Re. Plot no. 78, JmQ
Shed J

**KARACHI MUNICIPALITY.****NOTES SECTION.***Building Department.*

Re. Proposed building on plot 78, JM.5, Lower Mid.Class.Cal

PROPOSED BUILDING ON PLOT NO. 78, J.M.5

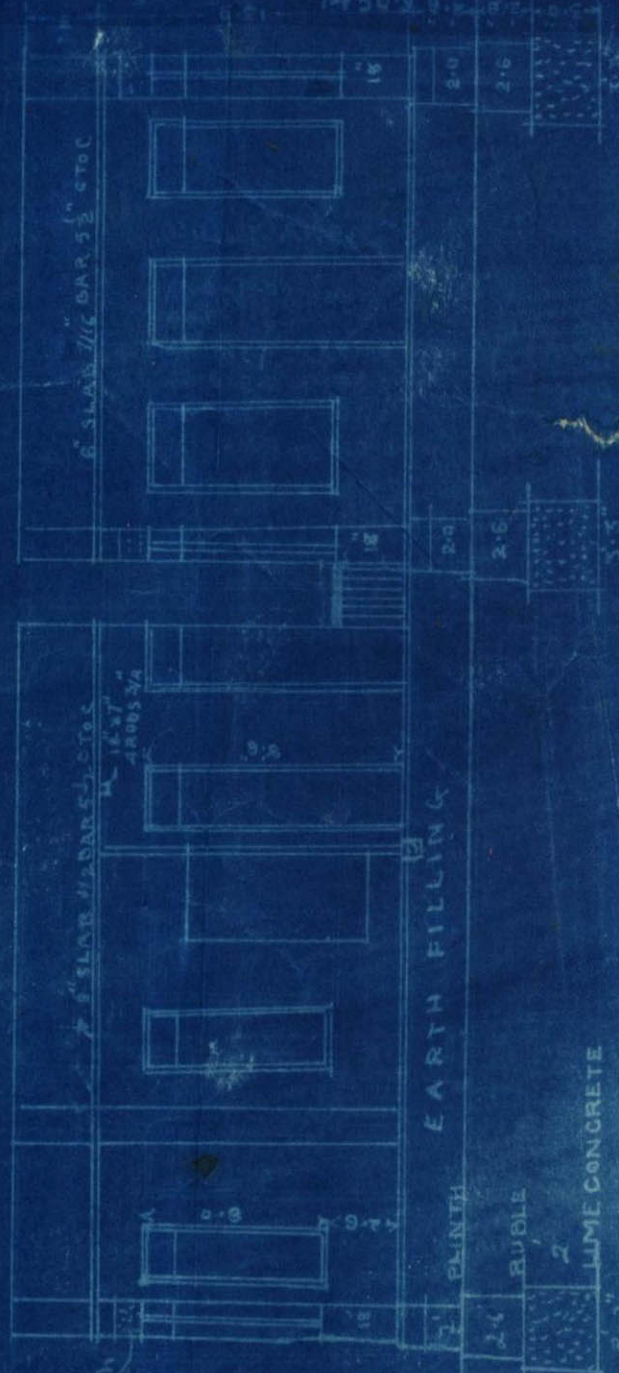
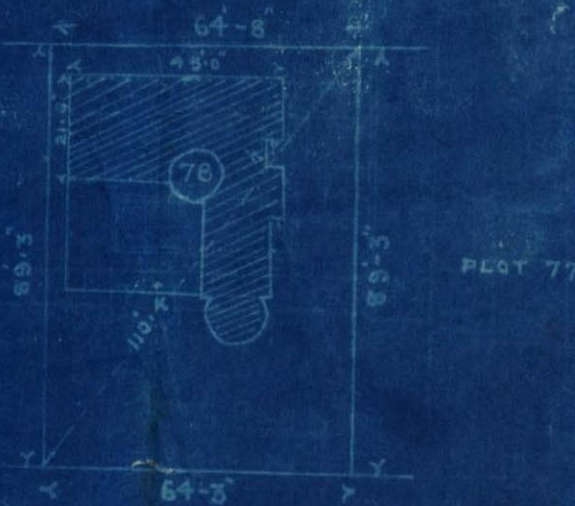
1. Blue prints are quite shabby. Better blue-prints must be submitted.

2. In the site-plan distances ~~of~~ from the ~~plot~~ bldg. to the boundary of the plot must be marked, and the spaces must be according to rules.

3. Size and reinforcement of R.C. Slab over Drawing Room is inadequate. They must be increased.

4. Width of 'pantry' is too narrow. It must be increased.

I don't see any necessity for such a long lease why not have a Central Polling

1. Blue prints are quite shabby. Better blue prints must be submitted.
2. In the site plan ~~distances~~ ^{distances} from the building to the boundary of the plot must be marked, and the spaces must be according to rules.
3. Size and reinforcement of R.C.C. slab over drawing room is inadequate. They must be increased.
4. Width entry is too narrow. It must be increased.
5. There is no necessity for such a long beam. A central pillar would do.

- (1) complied with. Fresh blue prints are herewith.
- (2) Distances have been marked in site plan.
- (3) Calculations accompanied the form A referring to the same you will find that effective depth required was only 4'2", the slab provided has been 6' and this is 20% stronger than what it should be. However not to waste time unnecessarily over this, I am increasing the size to 7 inches and reinforcement from 7/16" to 1/2".
- (4) Width of pantry has been increased from 3ft to 4ft.
- (5) Central pillar 18" sq. with 4 rods 1/2" dia. has been provided.

PROPOSED BUILDING ON PLOT NO.78.J.M.5

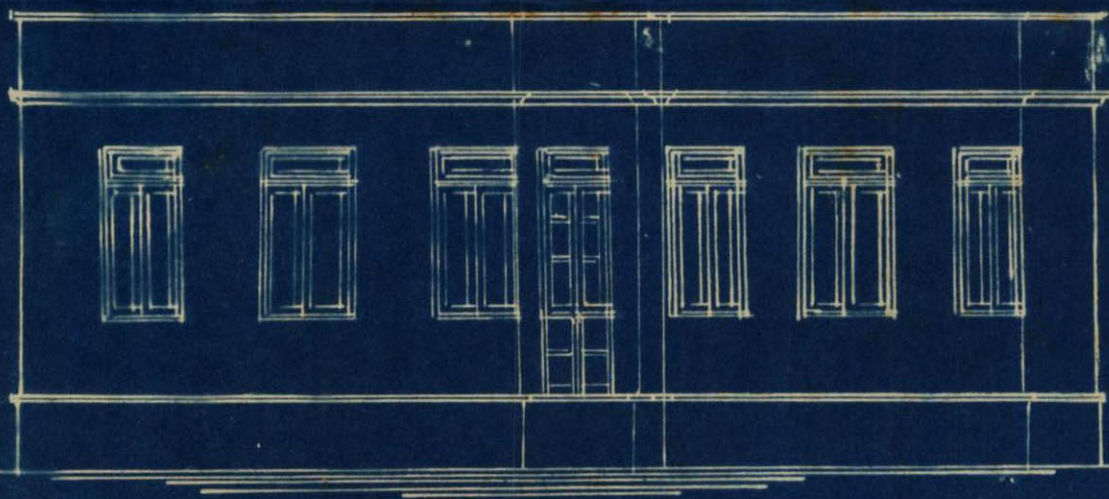
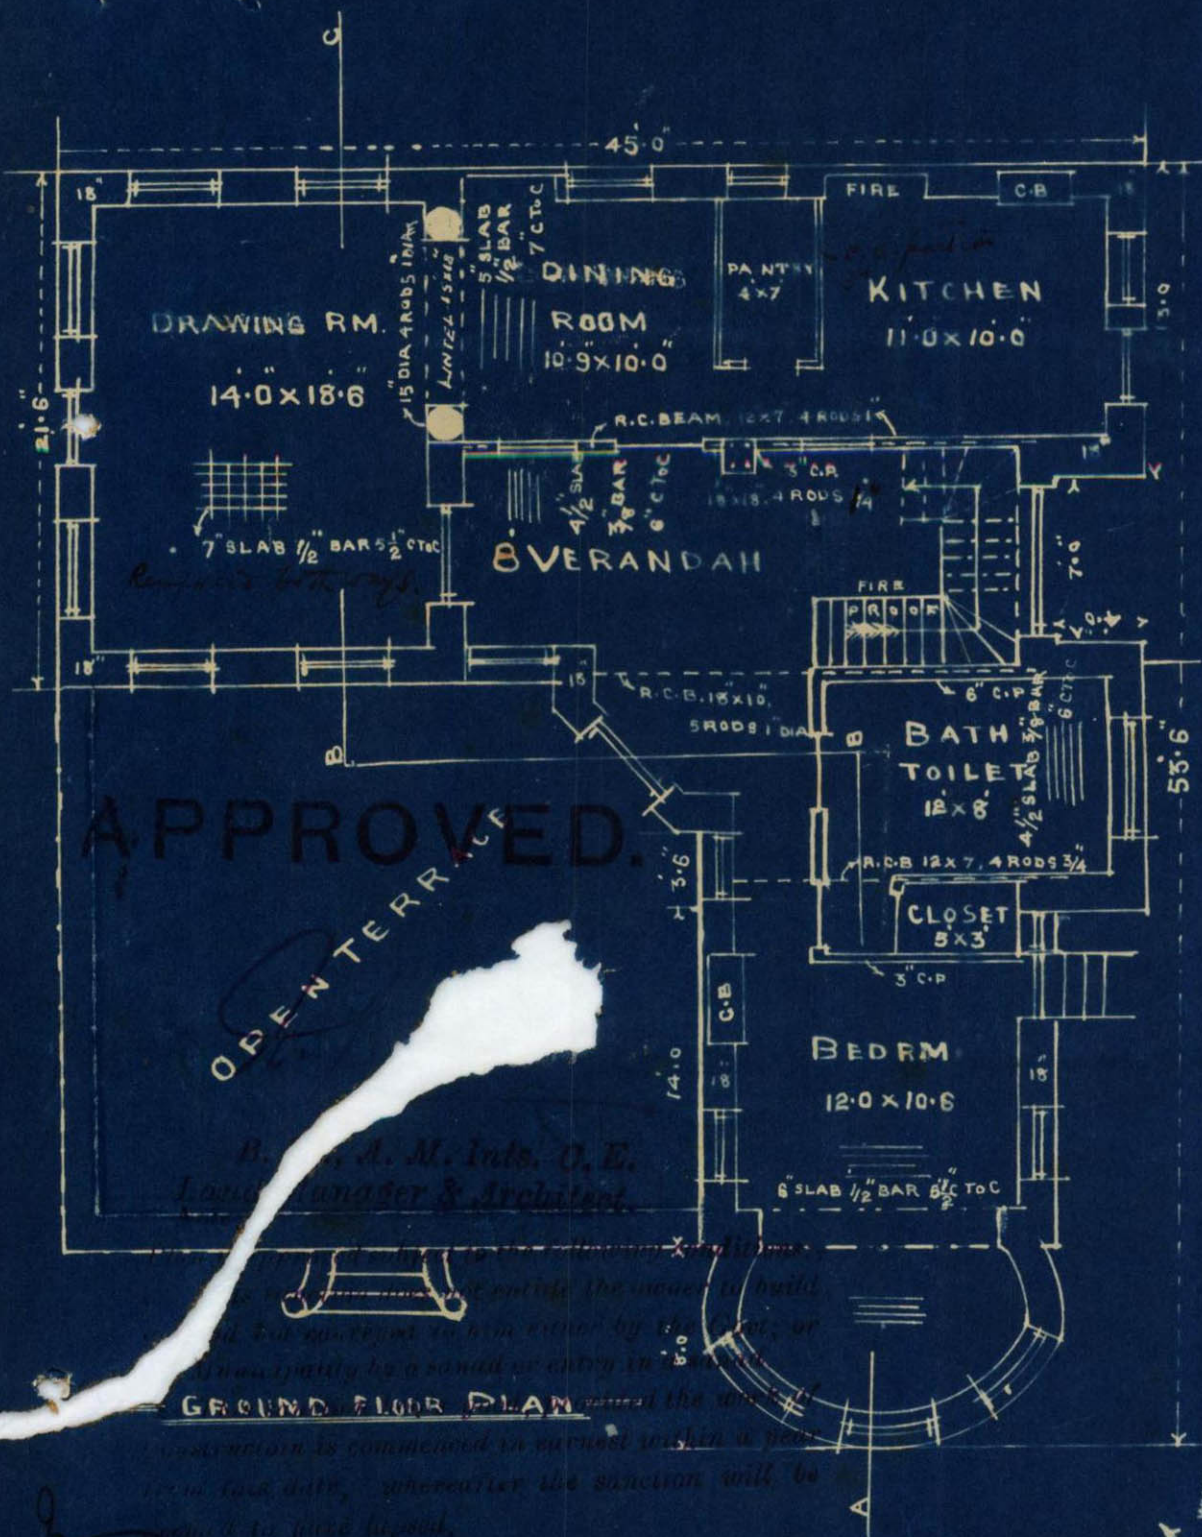
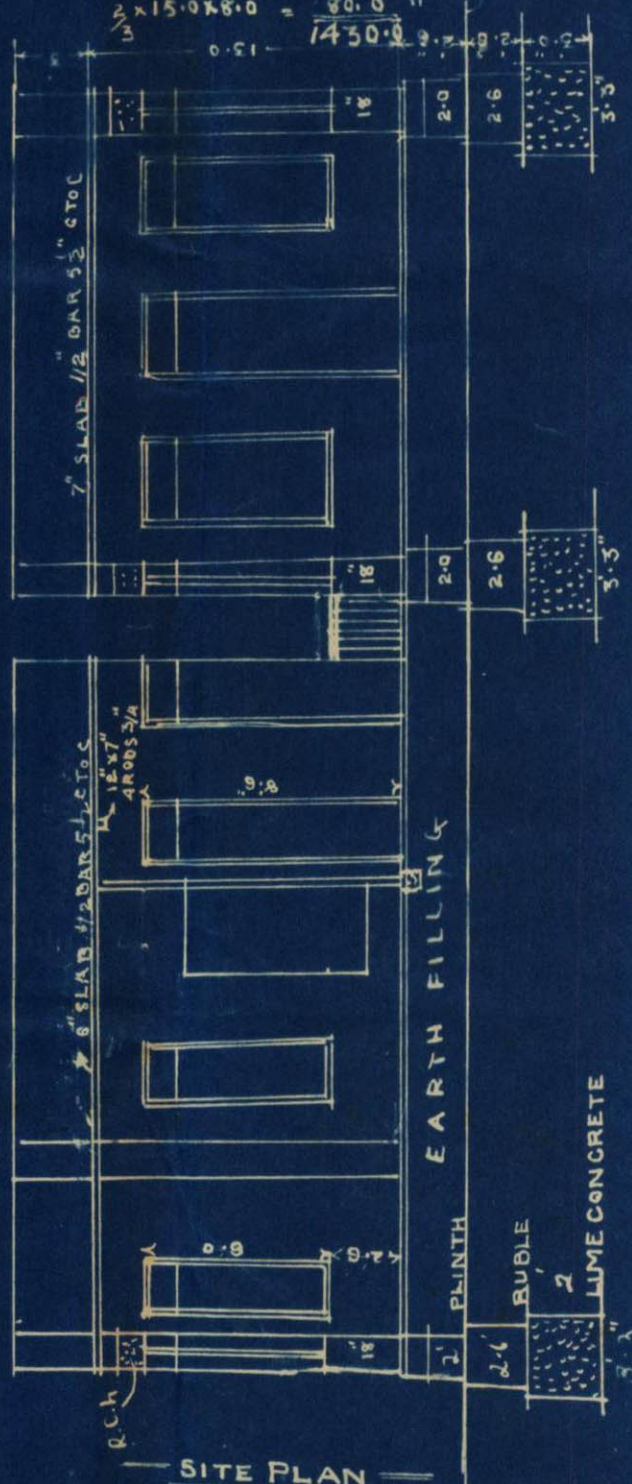
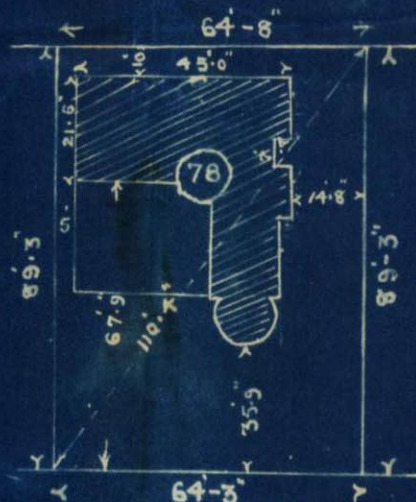
Requirements
Complied with 16/6
